Appendix 5

Summary of Submissions and Proponent's Response to Submissions

Response to Submissions - CSBP Final Remediation Works for the Former Cresco Site, Bayswater

Figure 3.1.3 Classification of ecosystem type for each of the broad categories of indicators (in grey boxes at left of the diagram)

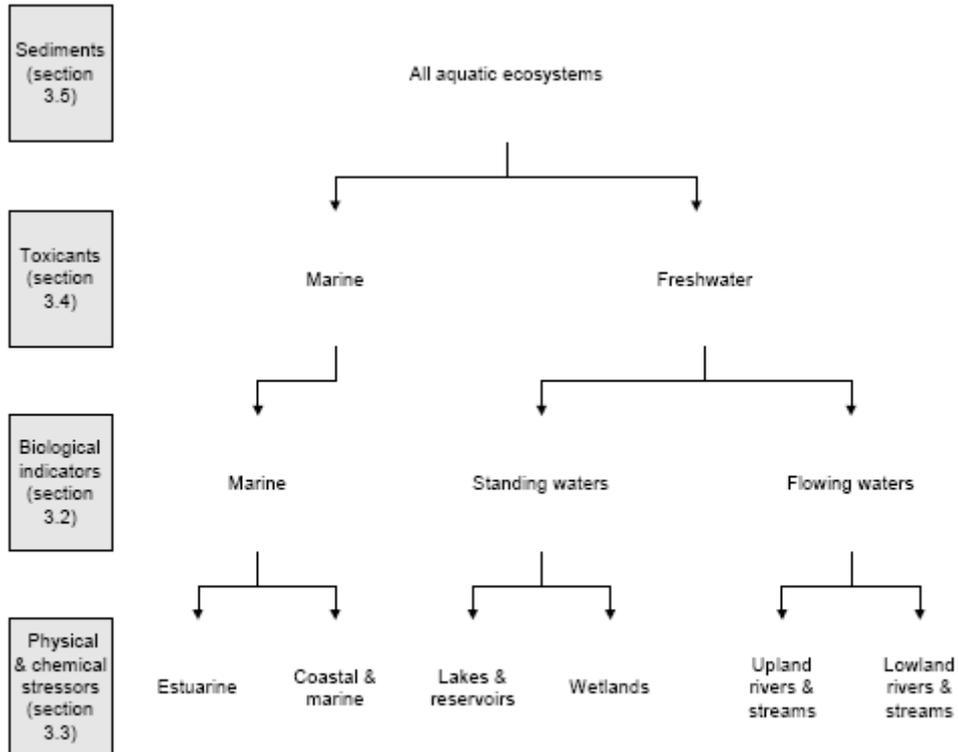
In liaison with the Swan River Trust (SRT), it was noted that the water quality criteria used to assess the acceptability of treated groundwater discharging to the Bayswater Main Drain and the Swan River was not that of a freshwater system.

Firstly, the Swan River in the vicinity and downstream of the Bayswater Main Drain may be described as a freshwater system, with salinity ranging from 3-4 parts per thousand. In the summer months it is fresh-brackish. The PER references marine ecosystem values as being appropriate for the water discharged from the BMD outfall, and treated water quality (following remediation) is to be assessed against these values. Could the proponent comment on whether freshwater ecosystem trigger values would be more relevant¹ for the assessment of concentrations of heavy metals and chemicals and that for physical and chemical stressors such as total nitrogen and total phosphorus, estuarine ecosystem values².

Thirdly, could the proponent comment on the use of freshwater ecosystem trigger levels for an urban drainage system (Bayswater Main Drain) that discharges to the Swan River.

Under the *Australian and New Zealand Guidelines for Fresh and Marine Water Quality* (ANZECC/ARMCANZ, 2000), an ecosystem classification decision tree (Figure 3.1.3, see below) is applied such that toxicants are split into one of two aquatic ecosystem types - marine and/or freshwater ecosystems. Importantly, the decision tree does not differentiate estuarine ecosystems, but rather sees these 'lumped' with marine ecosystems.

Under the above agreed national framework (upon which DoE's draft Assessment Levels for Soil, Sediment and Water is based), toxicants in estuarine ecosystems are to be appraised using marine trigger values.

In terms of physical and chemical stressors (including total nitrogen and total phosphorus), the *Australian and New Zealand Guidelines for Fresh and Marine Water Quality* (ANZECC/ARMCANZ, 2000) differs from that for toxicants in as much as trigger values specific to estuarine systems may also be applied. CSBP concurs with the Swan River Trust's view that for physical and chemical stressors, estuarine trigger values should be applied (in accordance with the decision tree, see below).
